## Technical Note

**Product Name:** T-1GD  
**Technical Note Date:** March 4, 2020

### T-1GD product notice – US-D size plastic control panels incompatibility

Figure 1: T-1GD Mounting Bracket

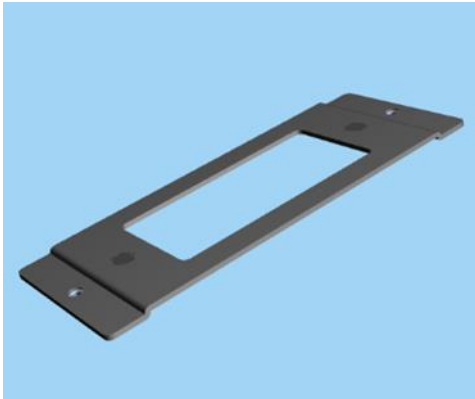
Kramer is upgrading the look of its US-D size panels for the following products: RC-206, RC-306, RC-208 and RC-308. The upgraded panels are plastic and a bit larger than the current metal panels. This causes difficulties in installing the US-D size products in a TBUS using the current T-1GD bracket.

The modified T-1GD bracket is in production now and will fit both US-D size panel versions, plastic and metal.
